Access Compliance Report

Public Rights-of-Way

(Curb Ramps)

Intersection ID: 10026412	Main Street: FARM_POND_LN	Cross Street: N/A	Location: NW
ADA ID: A52724352A3C	Ramp Type: PerpDiag	Initial Pass/Fail: Fail	Overall Compliance: No
		Severity Score: 12.5

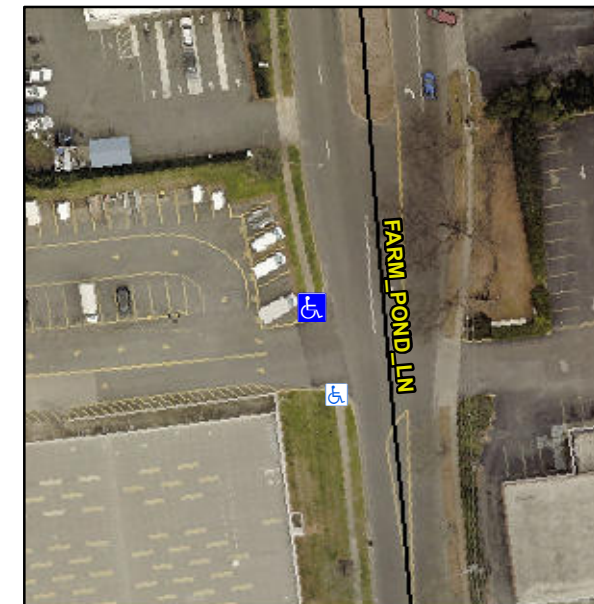
Not Found, R304.2.2

Compliance	Description	Data	Compliance	Description	Data
N/A	Ramp Length (in)	36.0	No	Ramp Slope (%)	10.7
Yes	Ramp Width (in)	48.0	Yes	Ramp XSlope (%)	0.4
N/A	Flare Type LT	N/A	N/A	Flare Type RT	N/A
N/A	Flare Slope LT (%)	N/A	N/A	Flare Slope RT (%)	N/A
N/A	Flare Traversable LT?	N/A	N/A	Flare Traversable RT?	N/A
N/A	Landing Length (in)	N/A	N/A	DWS Provided?	N/A
N/A	Landing Width (in)	N/A	N/A	DWS Contrast?	N/A
N/A	Landing Slope (%)	N/A	N/A	DWS Length (in)	N/A
N/A	Landing X Slope (%)	N/A	N/A	DWS Full Width?	N/A
N/A	Landing Curb? (Y/N)	N/A	N/A	DWS Offset (in)	N/A
N/A	Shared Landing?	N/A			
N/A	Gutter Ponding?	N/A	N/A	Gutter Slope (%)	N/A
N/A	Gutter Lip Ht (in)	N/A	N/A	Gutter X Slope (%)	N/A
N/A	Painted X Walk1?	No	N/A	Painted X Walk2?	No
	X Walk 1 Direction	To S		X Walk 2 Direction	To E
N/A	X Walk 1 Width (in)	N/A	N/A	X Walk 2 Width (in)	N/A
	X Walk 1 Slope (%)	2.2		X Walk 2 Slope (%)	0.4
	X Walk 1 X Slope (%)	0.9		X Walk 2 X Slope (%)	1.3

Remove & Replace Curb Ramp With Two New Directional Ramps or Equivalent.
